SERVICE INFORMATION

APPLICABILITY: 2005-13MY Legacy and Outback Models with 5AT **NUMBER:** 16-91-14
 2006-13MY Tribeca **DATE:** 01/29/14

SUBJECT: Correction to Diagnostics for 5AT-Related DTCs:
 P0743, 748, 753, 758, 763, 768 and 773

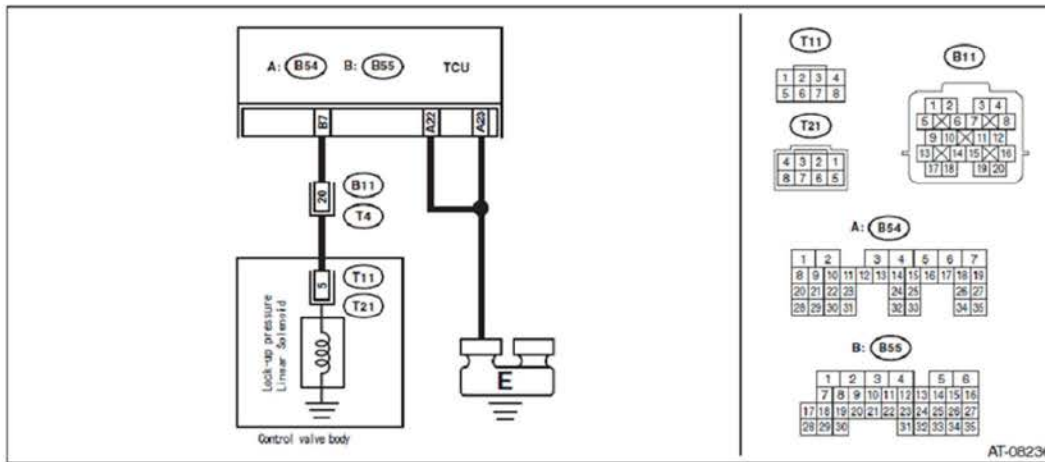
The connector number described above (T11) is the vehicle harness connector between the transmission control module and control valve body as shown in the schematic shown on pg. 2). The check is to measure the resistance between transmission ground and control valve body connector (T21), pin 5. Connector T11 should be labeled T21 (valve body harness connector).

Corrected step should read:

Step	Check	Yes	No
5. CHECK LOCK-UP SOLENOID. Measure the resistance between transmission ground and control valve body connector Connector & terminal (T21) No. 5 — Transmission ground:	Is the resistance 3 — 9 Ω?	Go to step 6.	Replace the control valve body.

The result of this check provides the resistance value for the lock-up solenoid.
